SITE PLAN

of
"THE HOMESTEAD"

for
KENNETH T. SOWUL

Grading Plan Approved

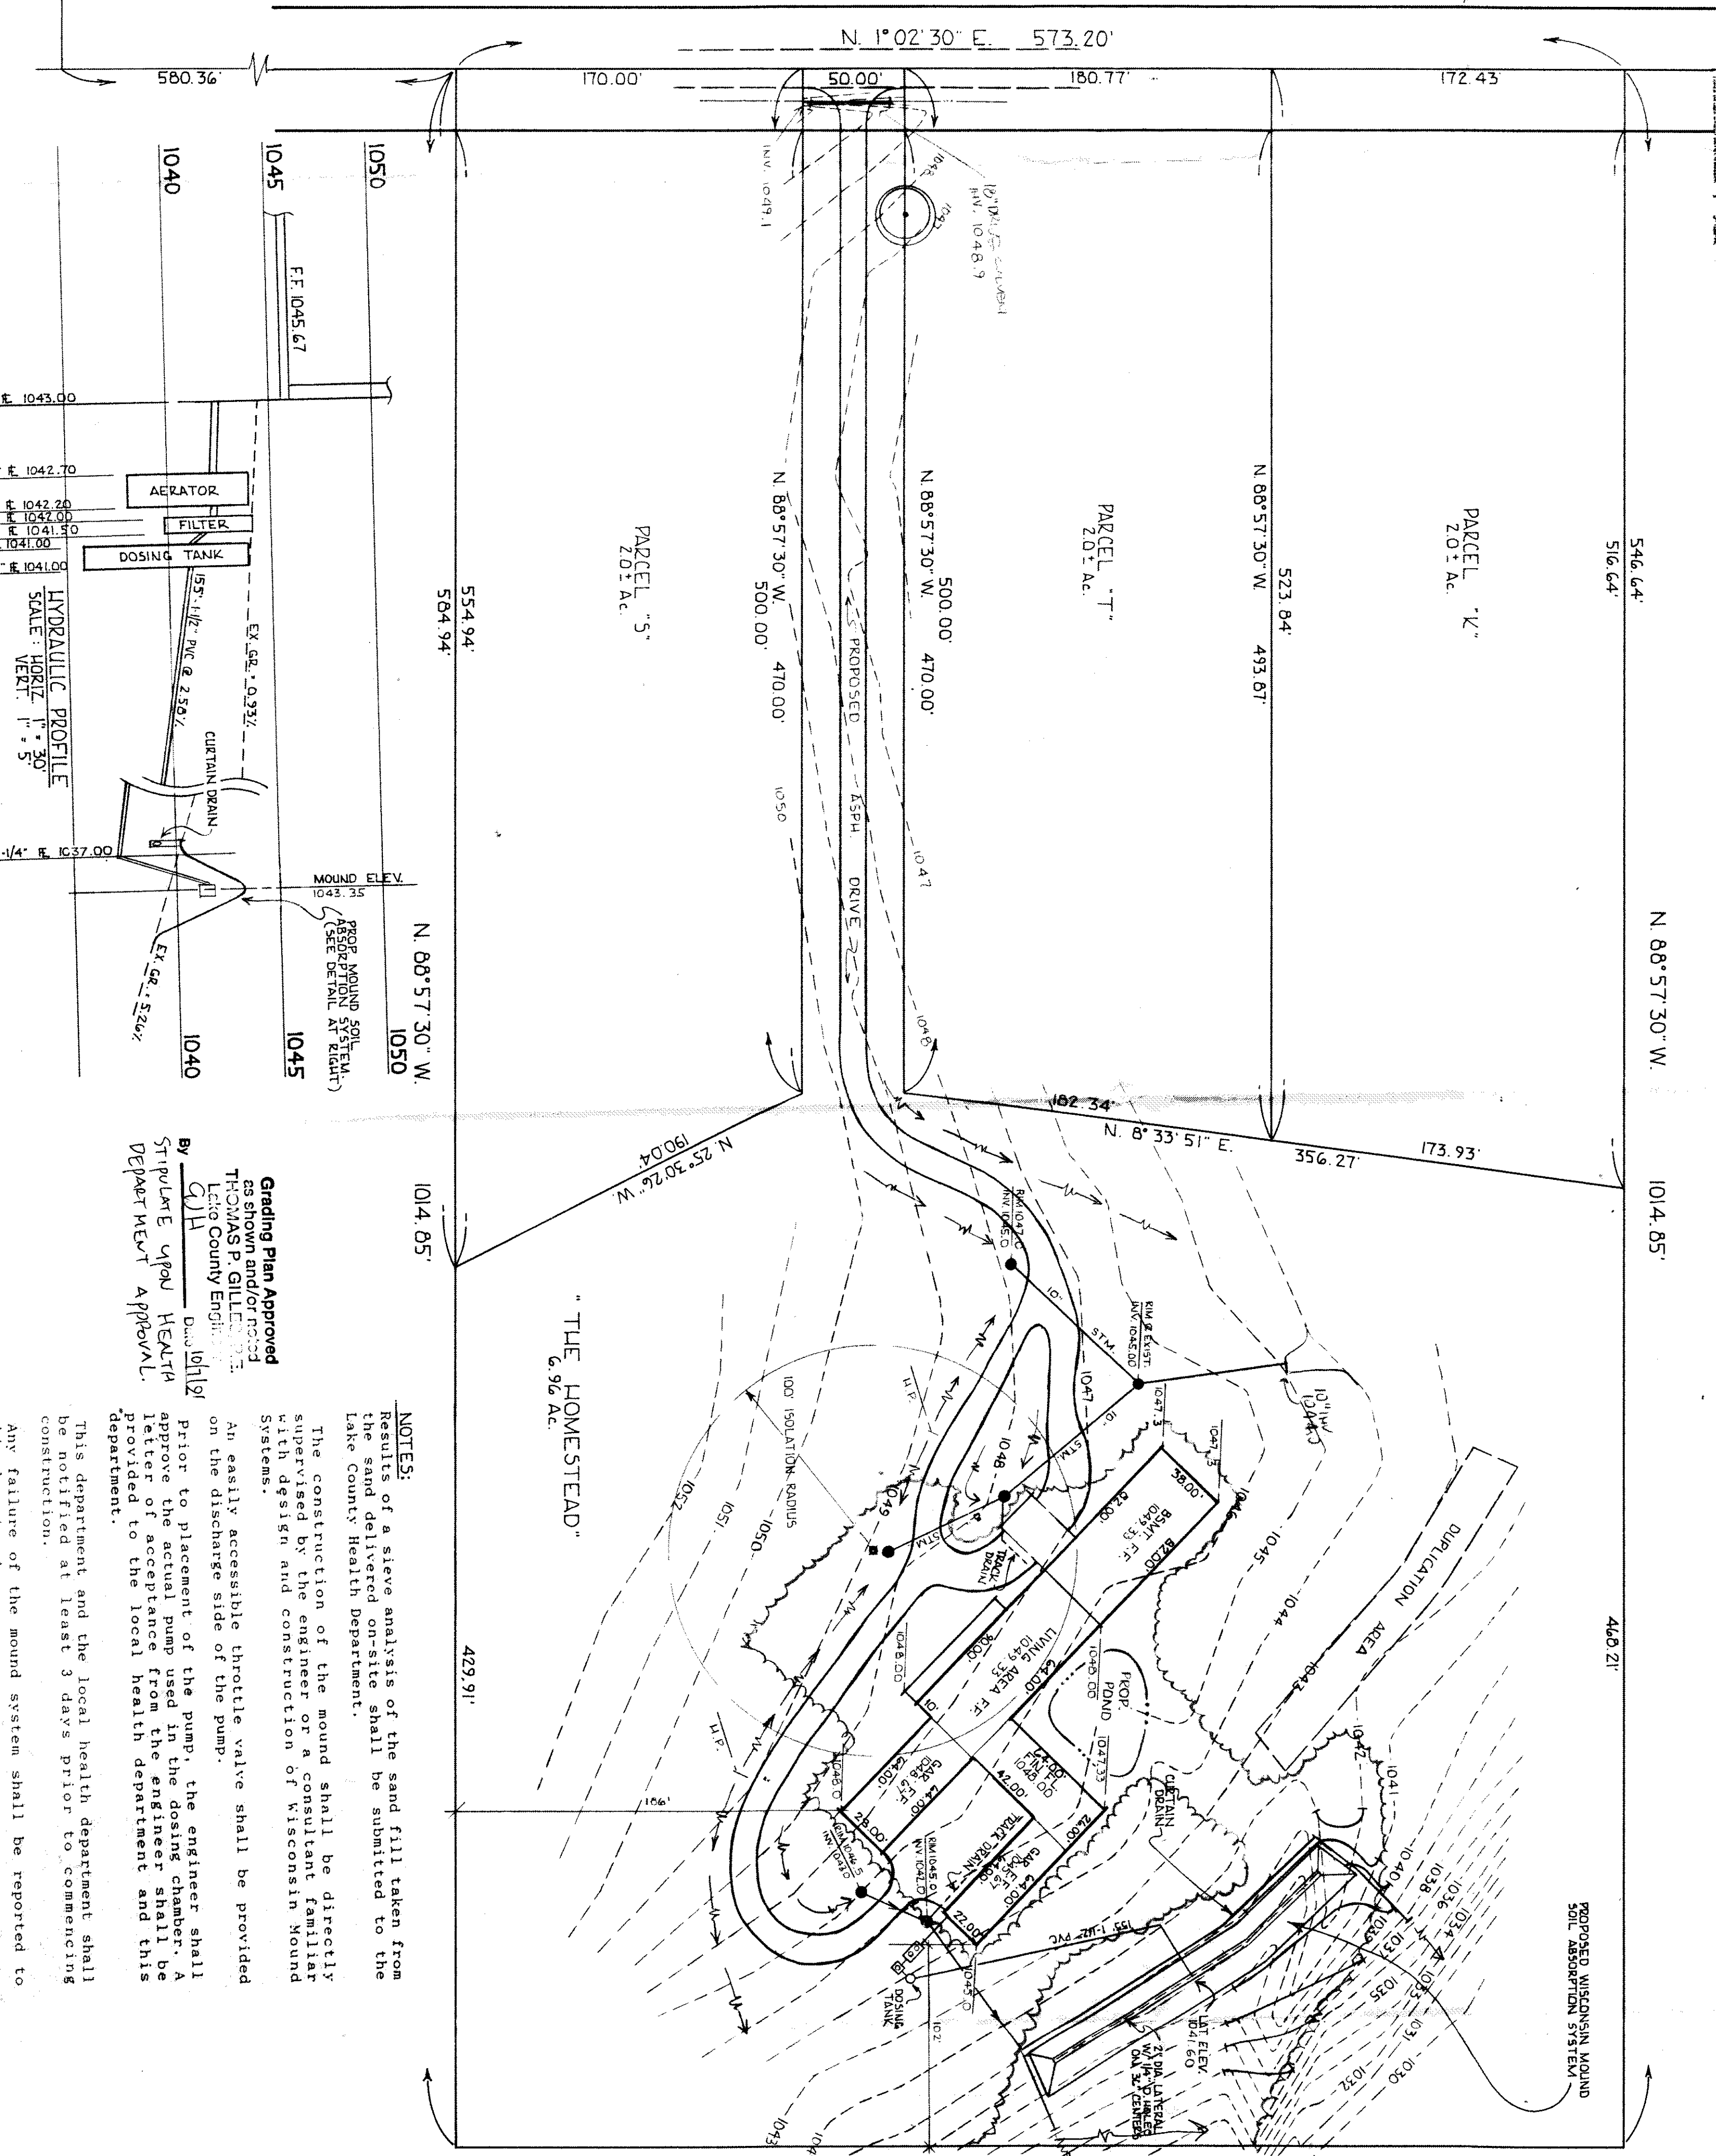
Stipulate upon Health Department Approval.

Results of a sieve analysis of the sand fill taken from the sand delivered on-site shall be submitted to the Lake County Health Department.

The construction of the mound shall be directly supervised by the engineer or a consultant familiar with design and construction of Wisconsin Mound Systems.

An easily accessible throttle valve shall be provided on the discharge side of the pump.

Prior to placement of the pump, the engineer shall approve the acceptance of the mound. A letter of acceptance from the engineer shall be provided to the local health department and this department.

This department and the local health department shall be notified at least 3 days prior to commencing construction.
